TOWN OF
QUEEN CREEK
ARIZONA

RE: PUBLIC HEARING AND POSSIBLE ACTION ON QUEEN CREEK VETERINARY CLINIC BUILDING EXPANSION CONDITIONAL USE PERMIT AND SITE PLAN (CASES P22-0118 AND P22-0204), A REQUEST FROM CAIN GARCIA, SPS+ ARCHITECTS, FOR A CUP AND SITE PLAN APPROVAL FOR THE CONSTRUCTION OF AN APPROXIMATELY 4,400SQ.FT. BUILDING ADDITION AT THE EXISTING VETERINARY CLINIC, LOCATED EAST OF THE SOUTHEAST CORNER OF OCOTILLO AND HAWES ROADS.

DATE: November 9, 2022

1 SITE PLAN
3/32' = 1'-0"

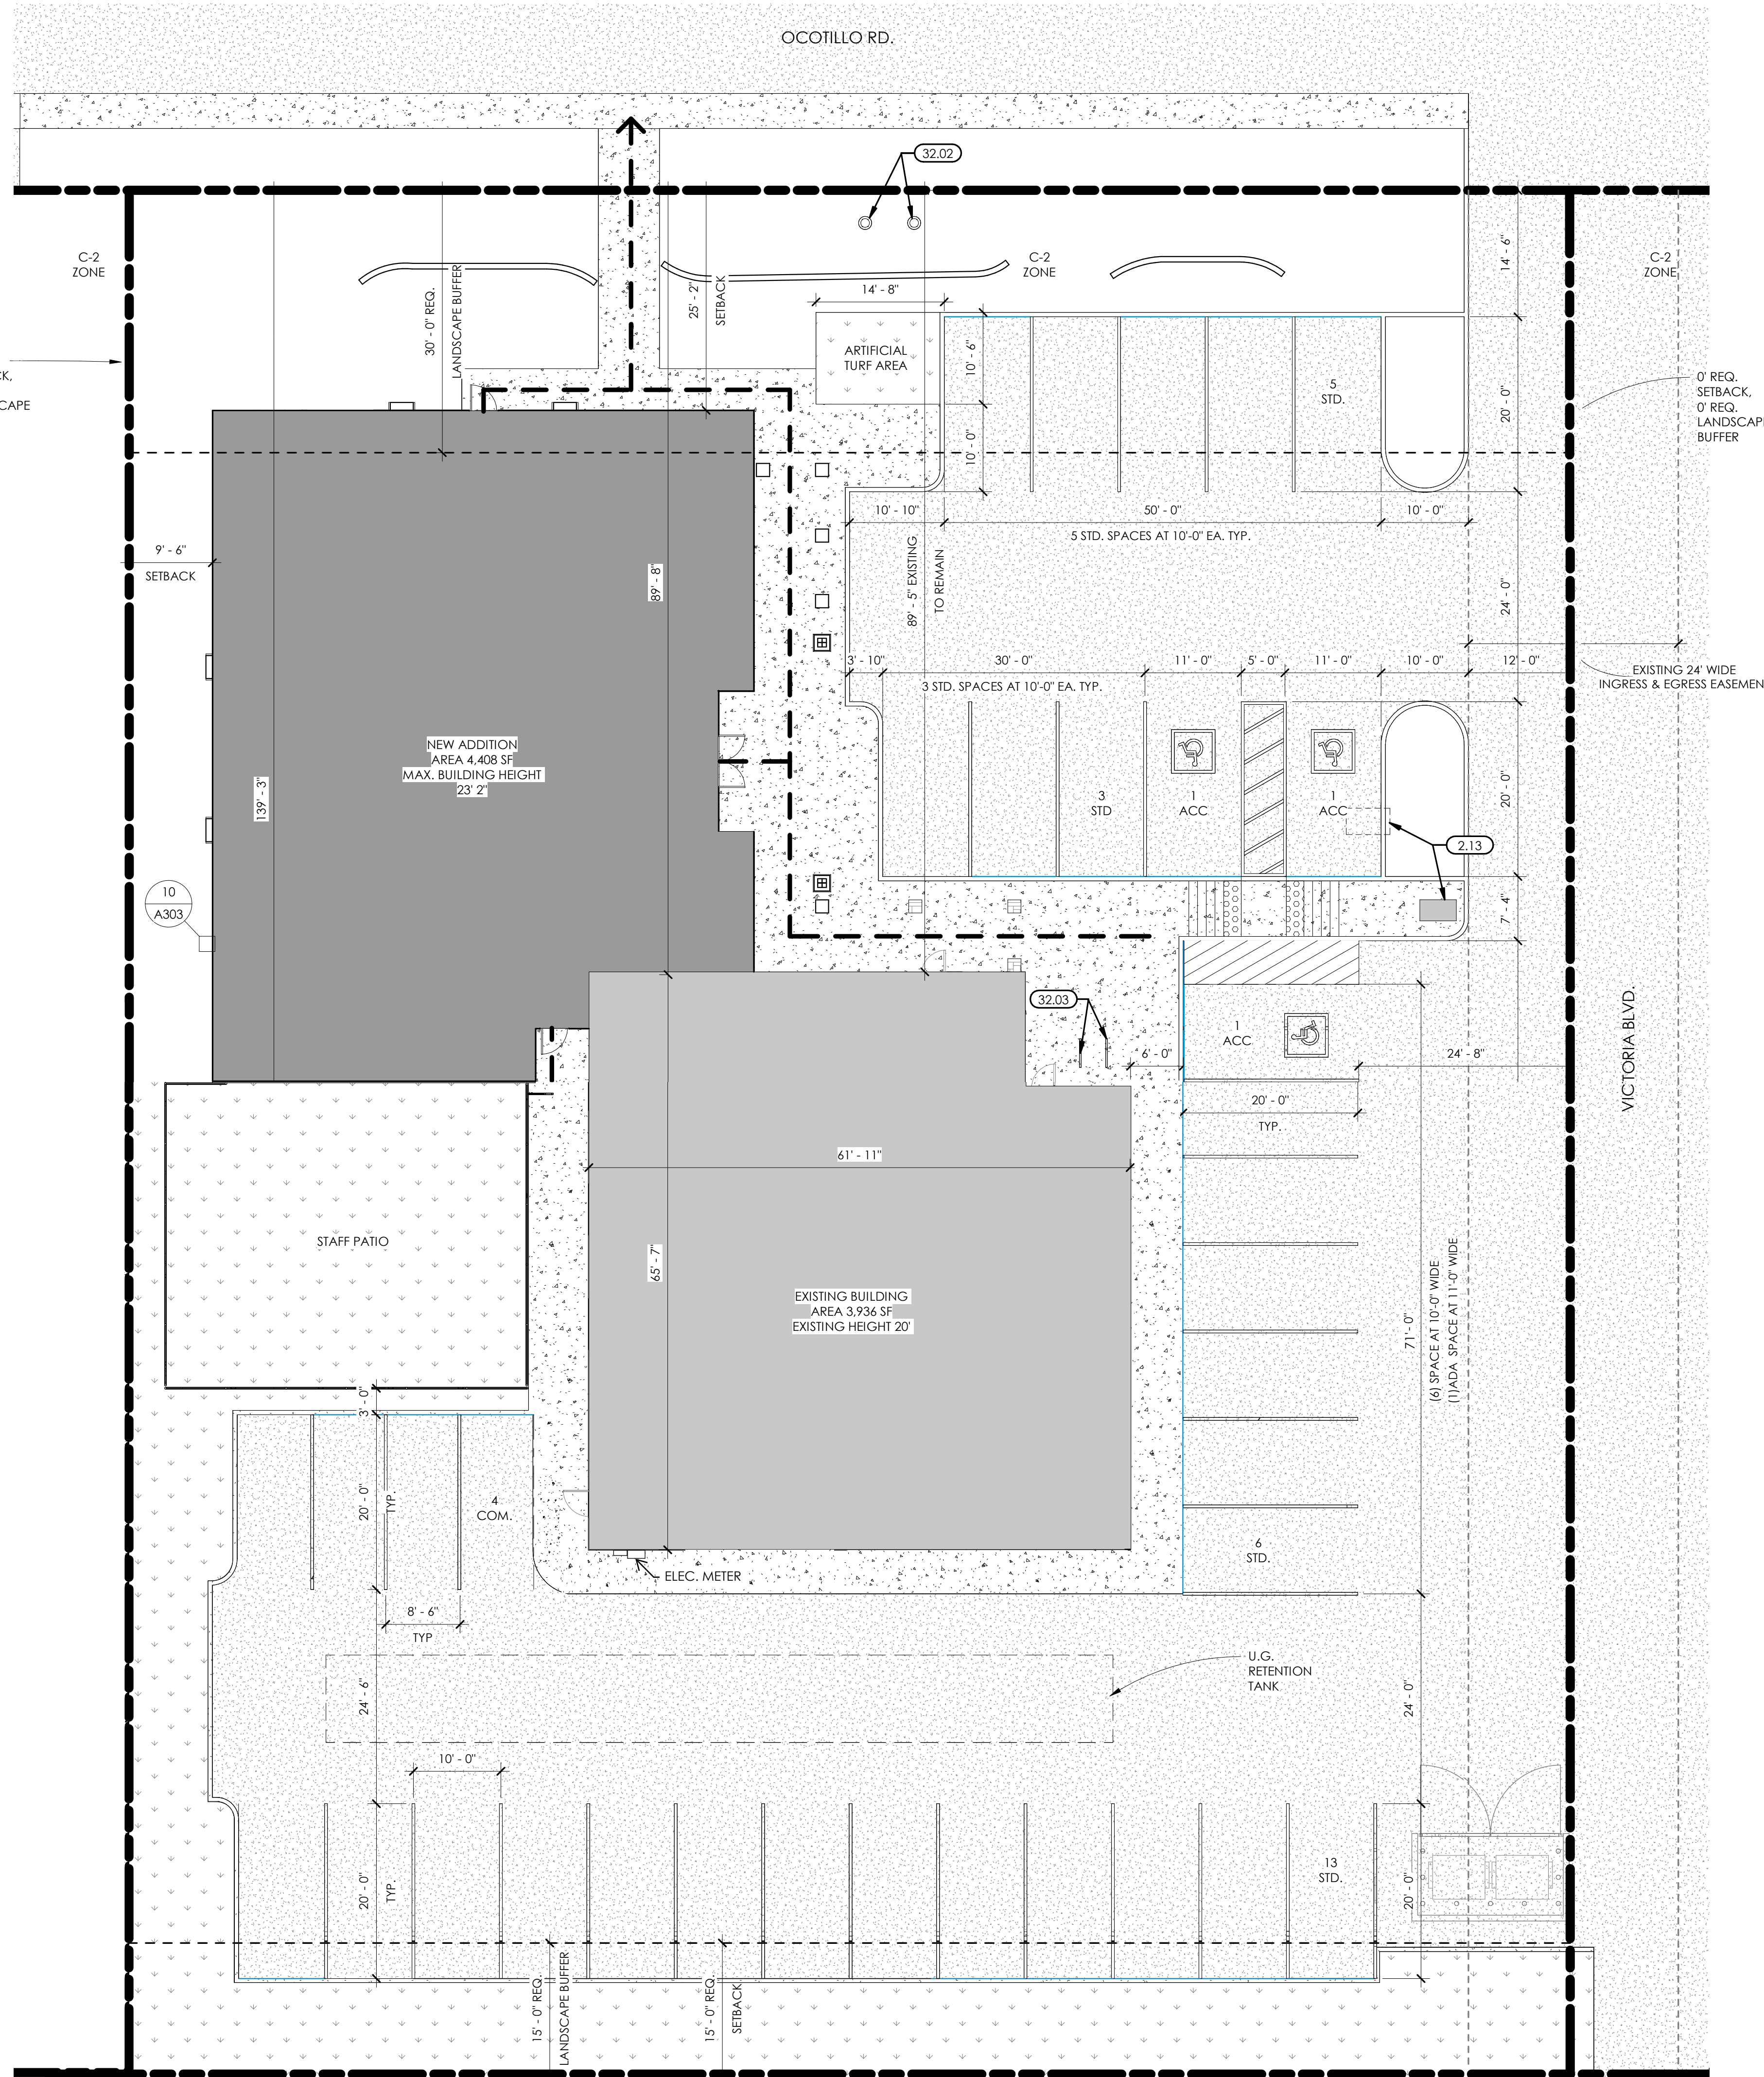
The project meets all lot coverage and building setback requirements, however, the landscape buffer requirements are not met at the north and south property lines. The required landscape buffer at the adjacent to Ocotillo, is 30' from the subject site's north property line. The applicant is proposing a 25'2" landscape buffer. The distance from the property line to back of curb at Ocotillo Road is approximately 30'. Therefore, the total buffer from back of curb is approximately 52'2". The proposed 25'2" on-site landscape buffer setback is consistent with existing buildings adjacent to the east and west of the subject site. Given the existing conditions in the area, the reduced landscape buffer at the north property line is supported by staff.

Similarly, the required landscape buffer at the south property line is 30' adjacent to the single family residential use. A 50% proportional share of the landscape setback is required to be installed along each property line, thus, requiring a 15' landscape buffer at the subject site along the south property line. The applicant is proposing a varied landscape buffer from 15' to 10'. The reduced landscape buffer is commensurate with the existing conditions at parcels to the east and west of the subject site. It should be noted that under case P22-0097, the parking lot expansion at the subject site was administratively approved and provided a 15' landscape buffer along the entirety of the south

property line. However, with the required drive aisle width, the landscape buffer was reduced to what is shown in the attached site plan. Seven trees and 47 shrubs will be installed within the southern landscape buffer. Given the existing conditions in the area, the reduced landscape buffer at the south property line is supported by staff.

A total of 42 parking spaces are required for the entire site. Of these 42 spaces, 22 are required as part of the building expansion. The Zoning Ordinance does not specifically delineate required parking for a veterinary clinic, and parking is calculated using the required parking count for a medical office. With past veterinary clinic/hospital projects, parking reductions have been justified as the intensity of use is less than that of a typical medical office. Additionally, the building expansion proposes 11 new exam rooms and an anticipated 2-3 employees. As represented by the applicant, the building expansion necessitates a maximum of 14 spaces. The proposed project provides an additional 17 parking spaces, for a site total of 32 parking spaces at the subject site. Staff is supportive of the requested parking reduction.

LANDSCAPE
PLAN

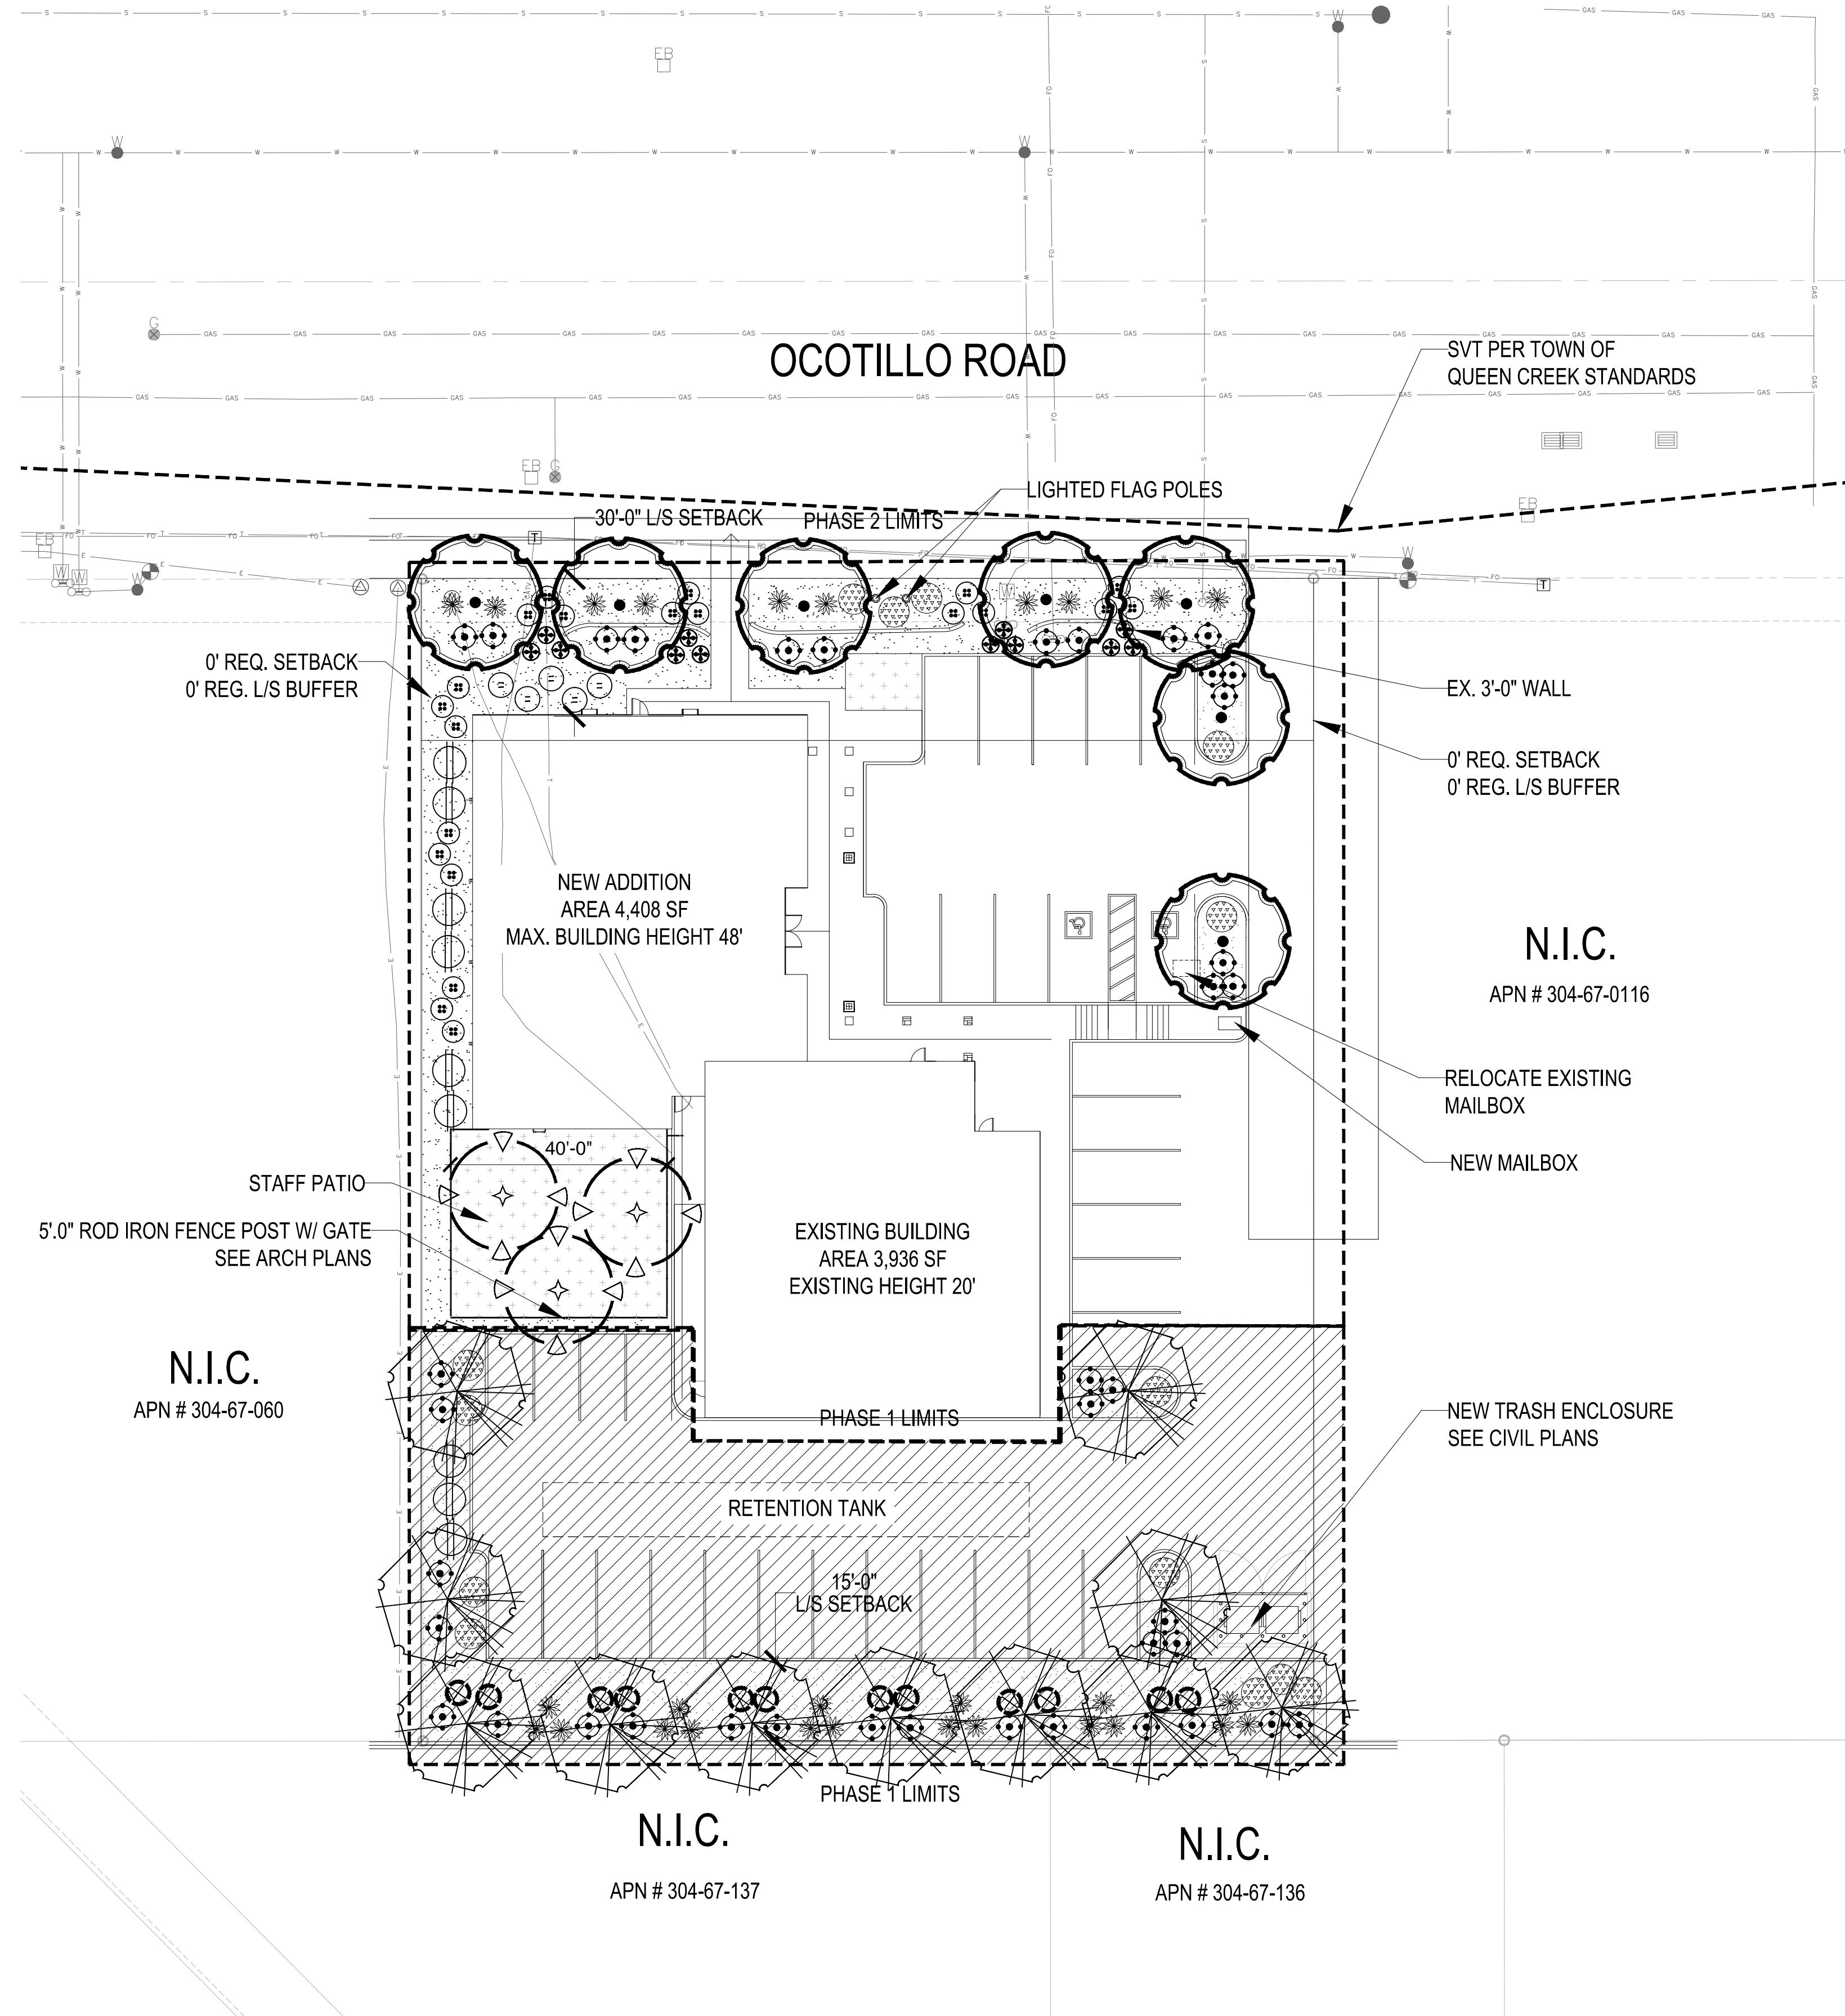
But I do have a question now about the trees. The desert sweet acacia trees produce an astounding amount of pollen. Perhaps some other trees that produce less pollen could be substituted? An possible substitution would be desert willow acacia, which is evergreen.
